# Past SS2 DMX Issues

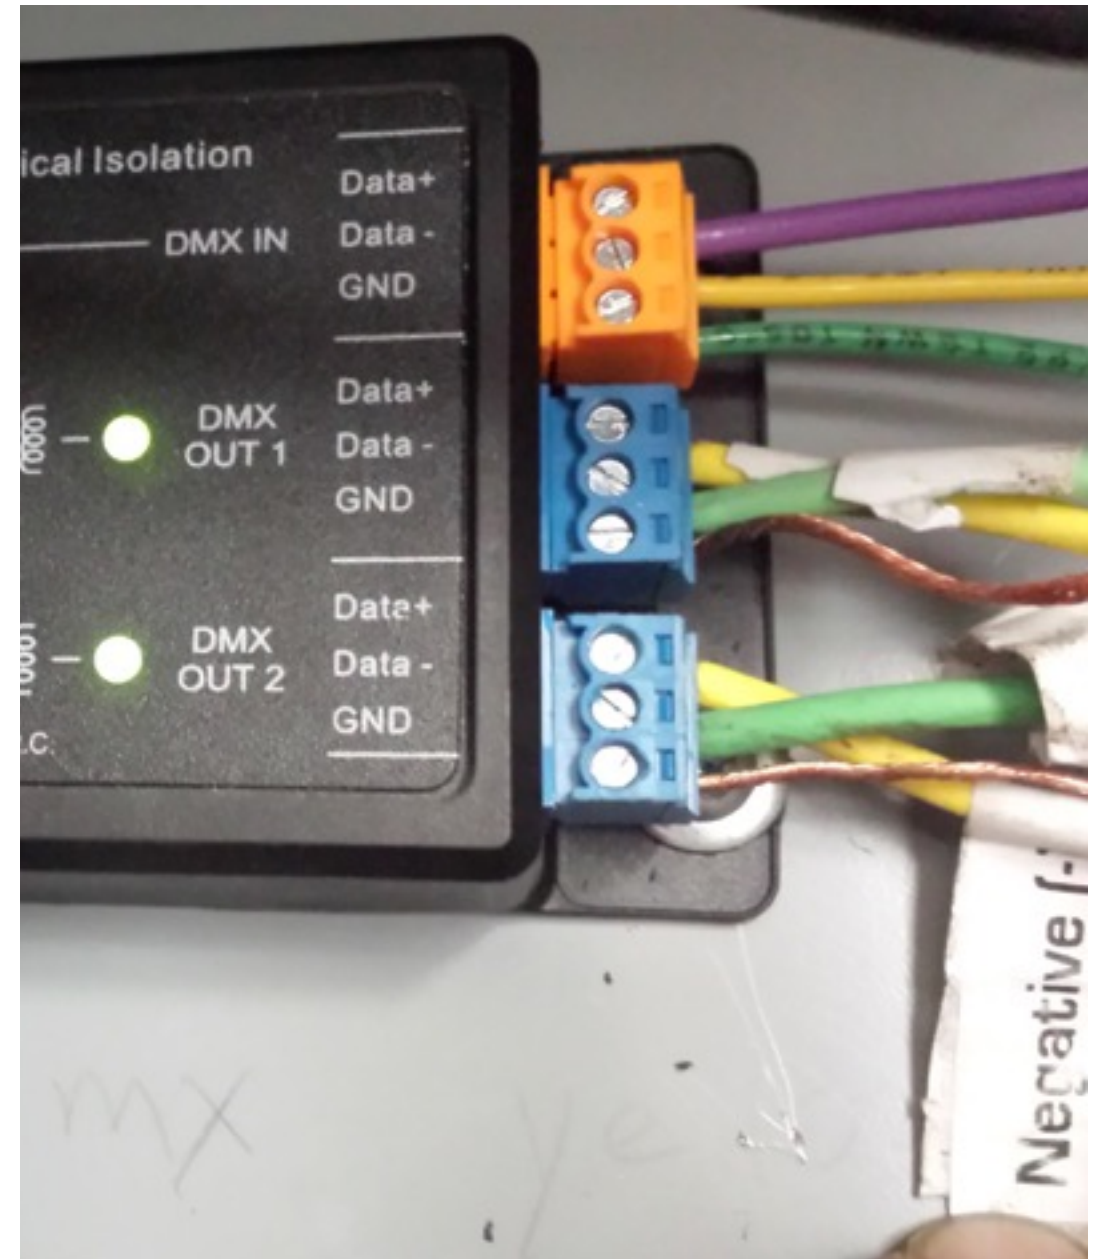
- Initial DMX output wiring has wrong polarity (green +, yellow -)

- Removed excess cable and properly terminated DMX output wiring

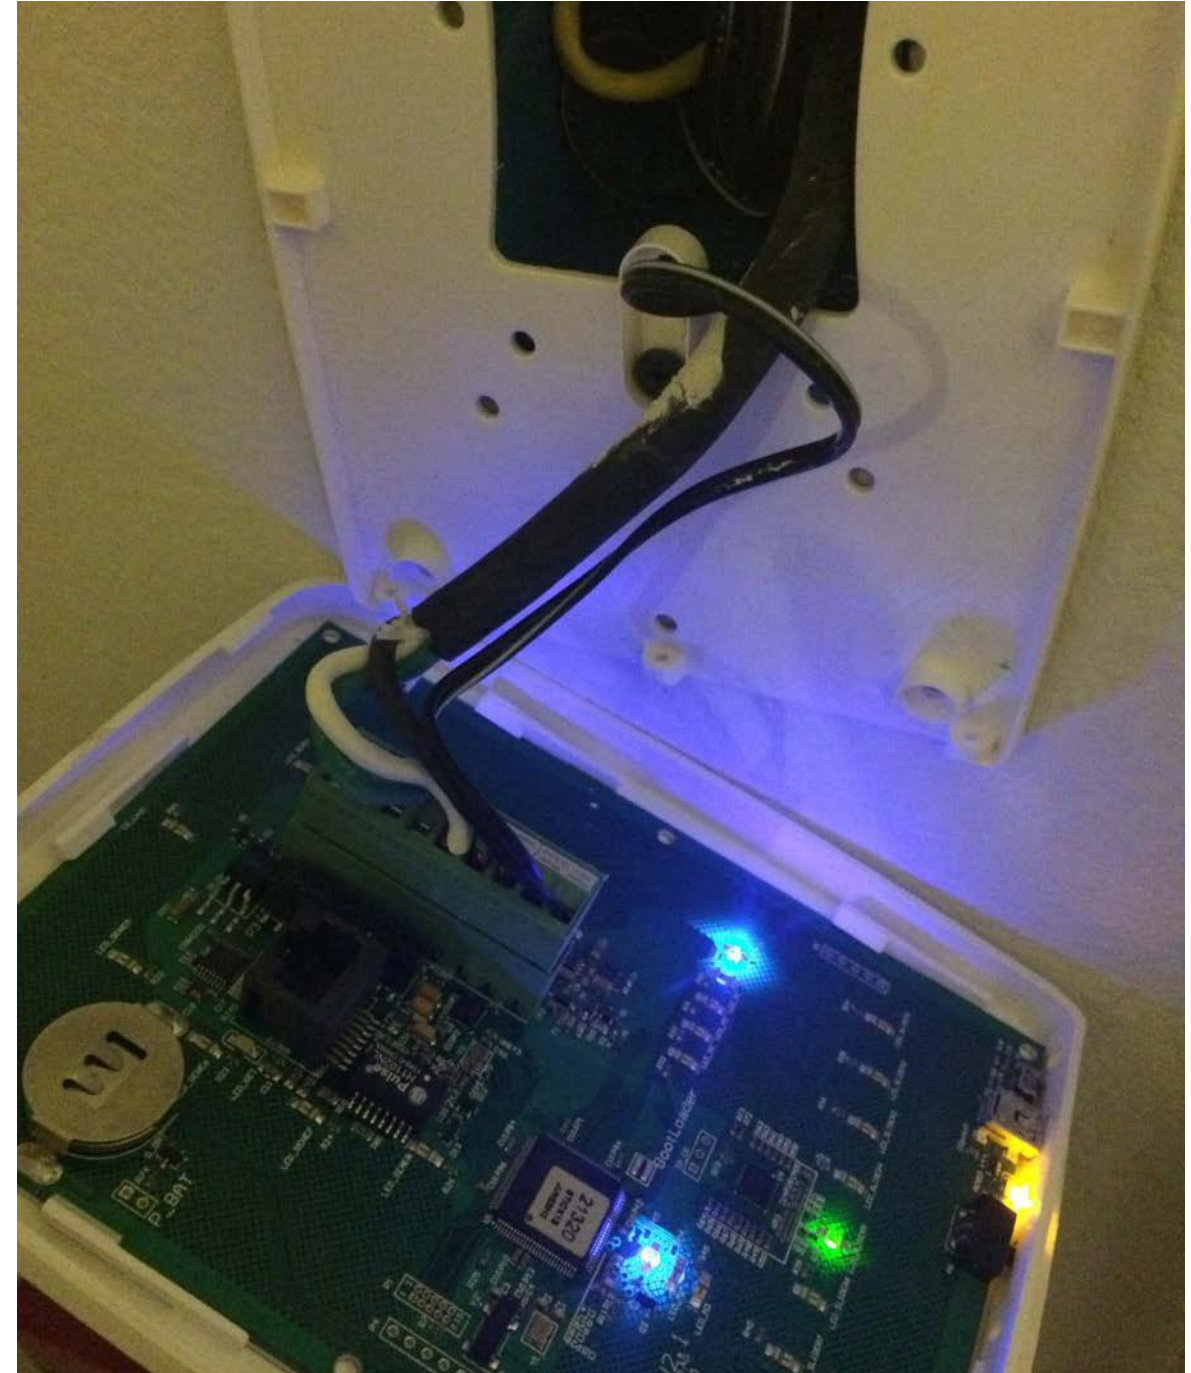
- Controller DMX output wiring is 14/3 power cable which is not DMX compatible

- Replace entire run with DMX compatible 120 ohm cable. Cat5e or better is a suitable alternative if inside metallic conduit. Color pinout would be as such:
  - White/Orange -> Data -
  - Orange -> Data +
  - Brown -> Data Ground

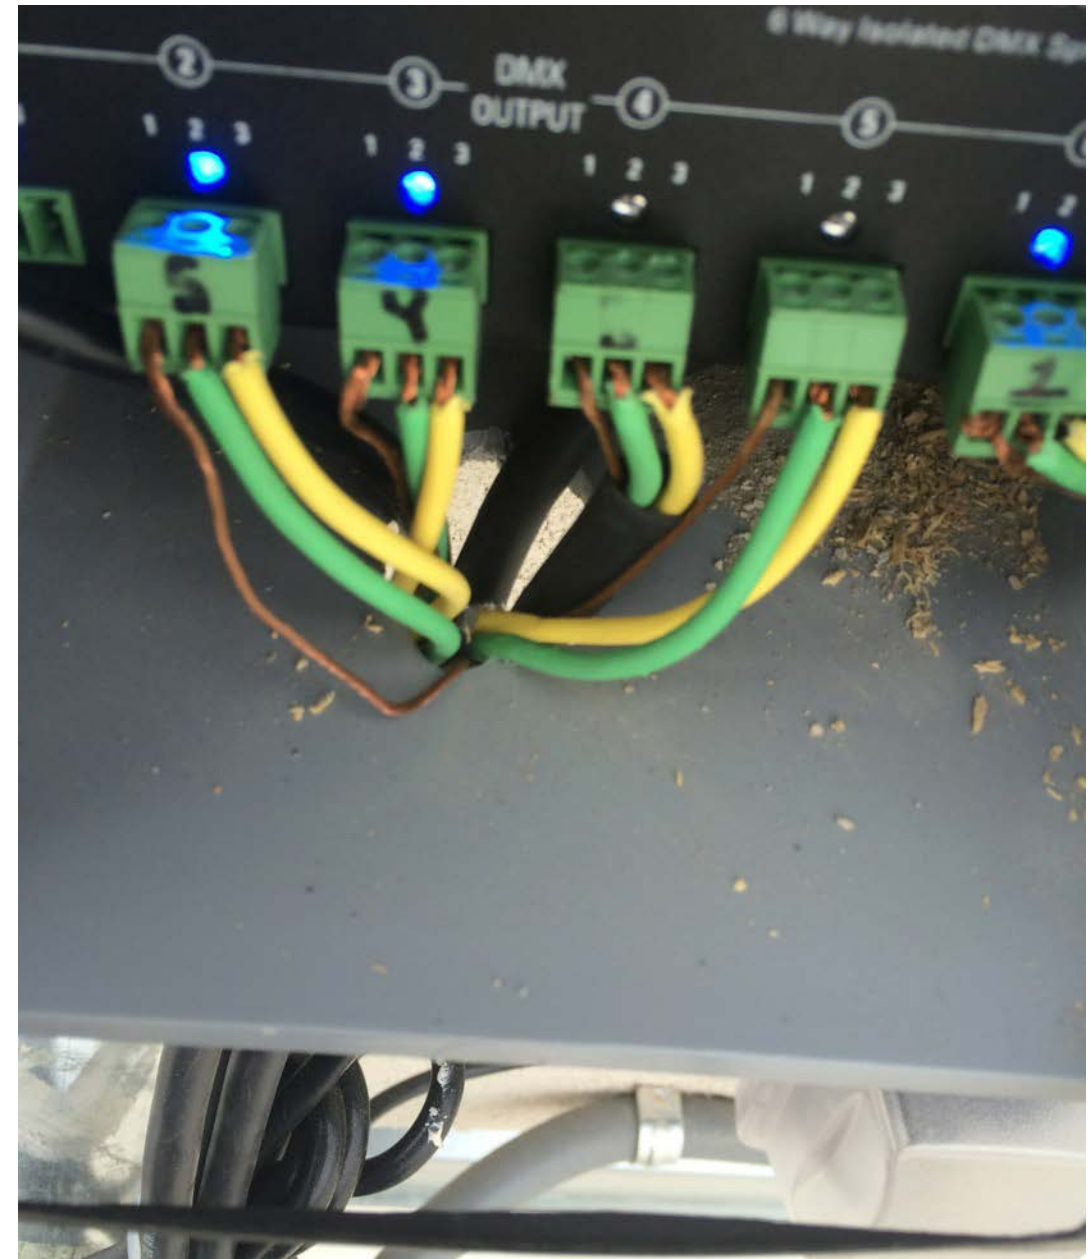
- Splitter enclosure has large hole in bottom where wires loosely feed into enclosure, possible moisture intrusion
- No cable strain relief, all weight of cables below are supported by Phoenix connectors
- Exposed copper shield wire and exposed copper in Phoenix connectors

- Replace enclosure with NEMA 4 rated enclosure
- Assuming individual cable runs, use water tight 1/2" cable grommet for each cable individually. Otherwise, run through conduit
- Use heat shrink for copper shield wires
- Ensure no copper wire is exposed when wiring into Phoenix connector

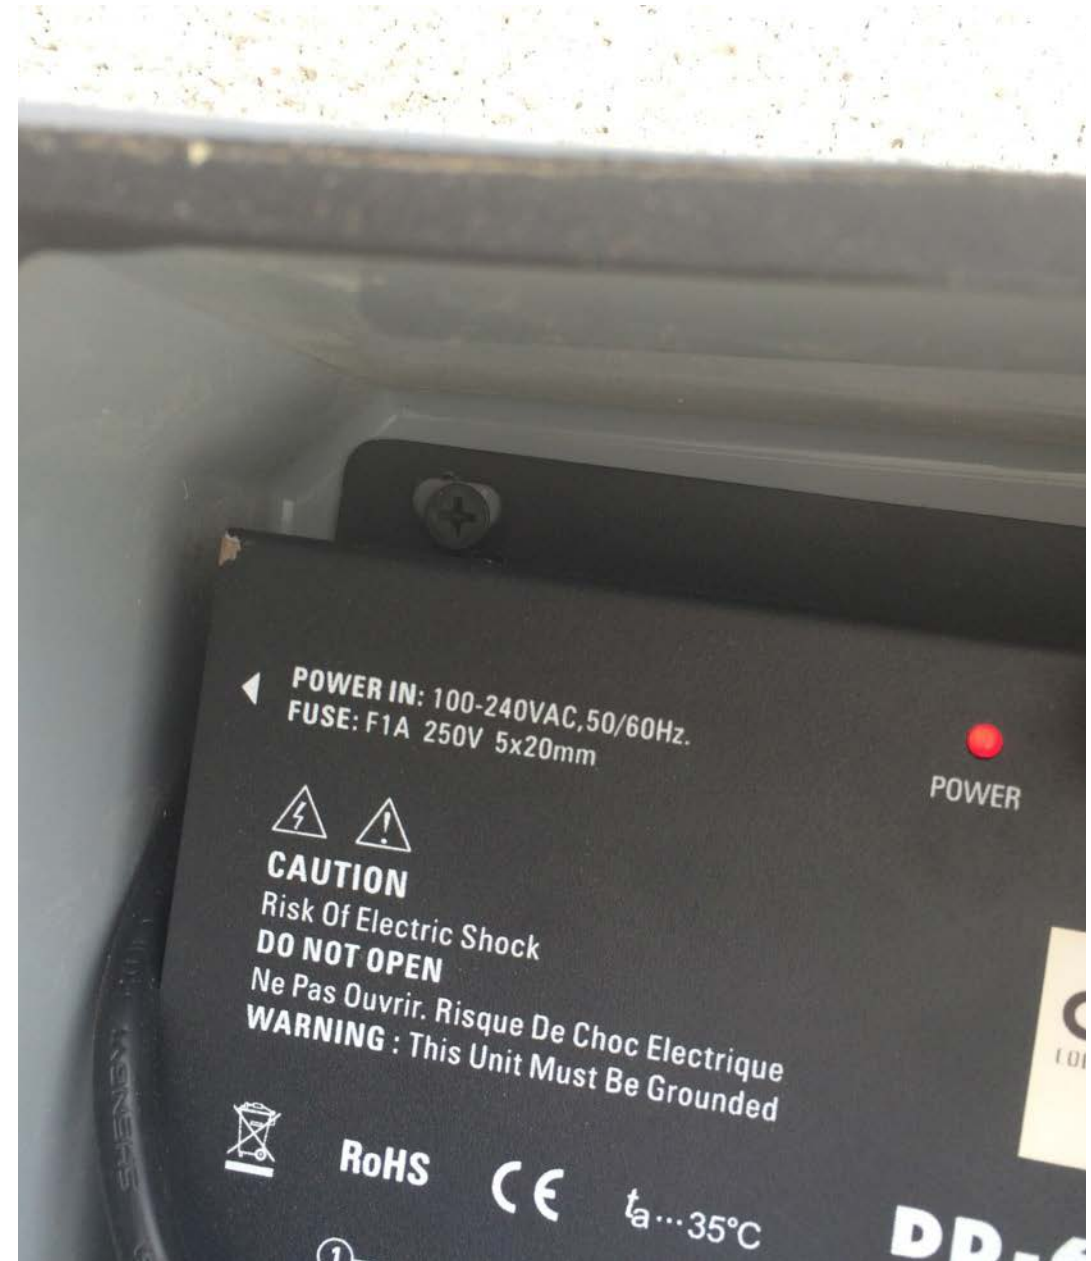
- Splitter mounted with drywall screws which penetrate through rear of enclosure

- Mount with alternative method to ensure moisture cannot enter enclosure

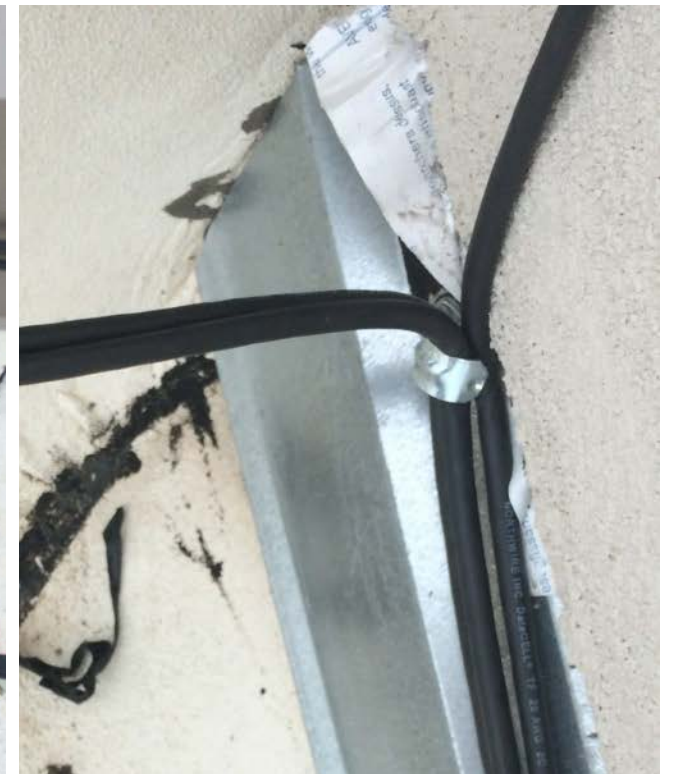
- Cable running along roof to right side is not fastened to structure
- Cable running along roof to left side is held too tightly against metal clamps. In the long term, cable jacket may become compromised or conductors could break

- Run all cabling in suitable sized conduit. With shielded wire such as the supplied Northwire DataCell 18/2, pvc would be acceptable. Should wire be switched out to Cat5e or better, EMT is recommended to aid in noise rejection and shielding
- Use clamps in parallel along wire run to avoid sharp 90° turns. Conduit preferred as it will have diameter bends.

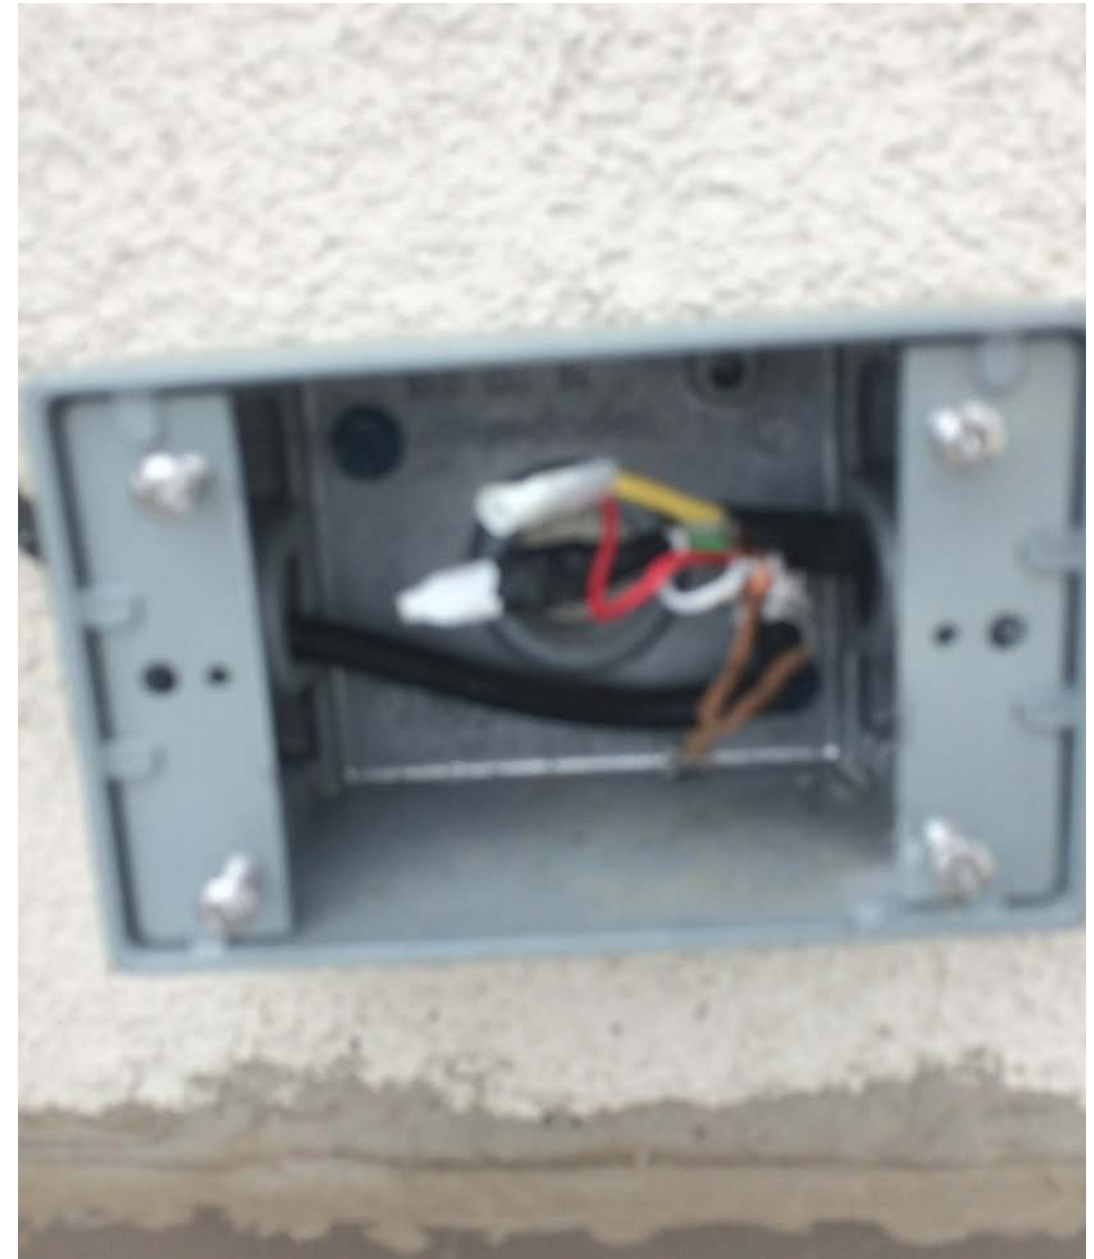
- Metal single gang boxes on right side towers only and do not have adequate waterproofing nor cable grommets
- Two towers on left didn't have boxes and had electrical taped terminations.
- No service loop in case of termination failure

- Use 1/2" weather proof cable fittings to ensure water tight connection
- All terminations should be enclosed in a water tight enclosure
